May 17, 2024

To: MT Department of Environmental Quality and MT Natural Resource Damage Program

Re: Upper Clark Fork River Operable Unit Phase 7 Design Comments

Figure 1. Clark Fork River channel migration zone map prepared by Applied Geomorphology, Inc.

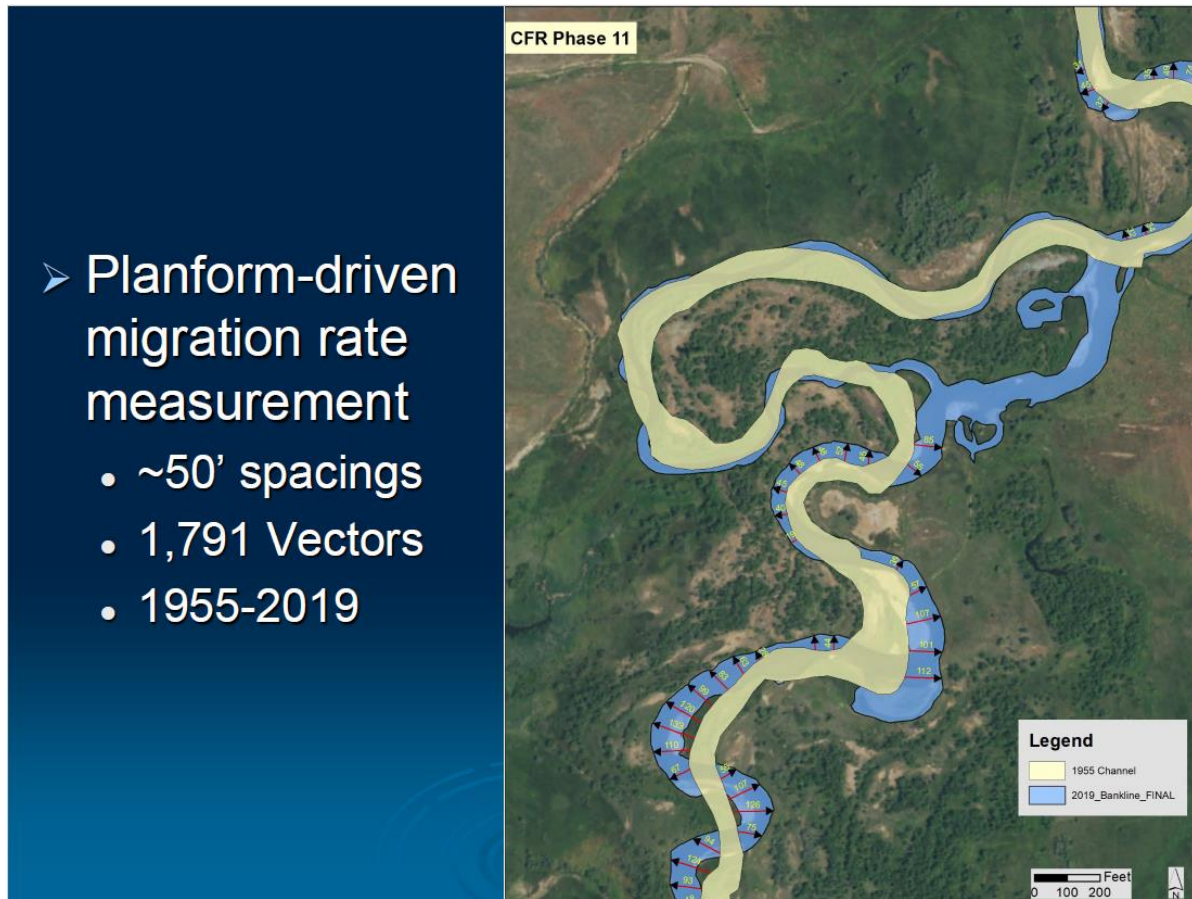
Comment 1: The use of CMZ mapping is a great tool for planning remediation and restoration activities near the river channel. The current methodology creates vectors for channel migration measured over 64 years of aerial imagery, then projects those vectors out over a span of 100 years and averages the lengths of all vectors to derive an average 100-year channel migration zone. The average 100-year migration zone is applied uniformly to Phase 7 and adjusted to improve constructability and tailings removal. This approach to CMZ mapping may be appropriate for managing an uncontaminated floodplain but may not be appropriate for the CFROU.

As the channel migration vector mapping shows (Figure 1), rivers do not erode uniformly. They tend to erode and migrate on outside meanders and in a down-valley direction. In addition, river channels occasionally avulse and erode new channels or reoccupy old ones. Using the average 100-year migration corridor would tend to reduce the amount of predicted erosion on outside bends and increase it on point bars.

The TAC recommends taking a different approach to channel migration zone mapping. Start by dividing the individual lengths of the mapped vectors by the 64-year period of record, then multiplying by 100 to yield an approximate 100-year migration corridor, just as was done for in the current mapping method. Then, those individual vectors could be adjusted by a constant factor (e.g. 75% or 50%) if needed to reduce the size of the migration zone for cleanup purposes. That would provide a more probabilistic map of expected channel migration. The migration zone map could then be augmented by using the HEC RAS 2-D model to evaluate floodplain shear stresses at, say, a 25-year discharge to evaluate the potential for historic channels to reactivate. Similarly, the avulsion risk analysis already performed by the design team would inform the final channel migration zone and tailings removal prioritization.

Figure 2. Composite of attachments 1 and 2 from the Phase 7 Design Memo, highlighting some areas where avulsion pathways extend beyond the calculated 100 year channel migration zone.

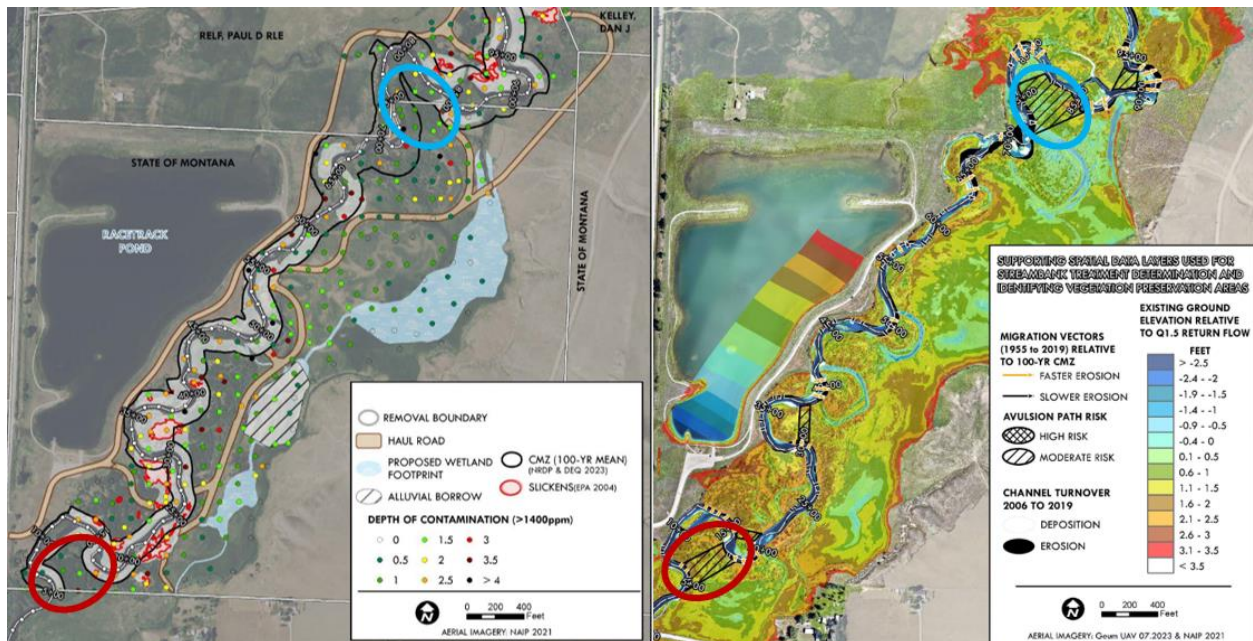
The avulsion risk analysis already performed by the design team could also inform the final channel migration zone and tailings removal prioritization. Under the current approach, many areas identified as avulsion pathways are outside of the identified 100-year CMZ (Figure 2). This presents a clear contradiction and reveals limitations of the average migration rate approach currently used to determine the CMZ.
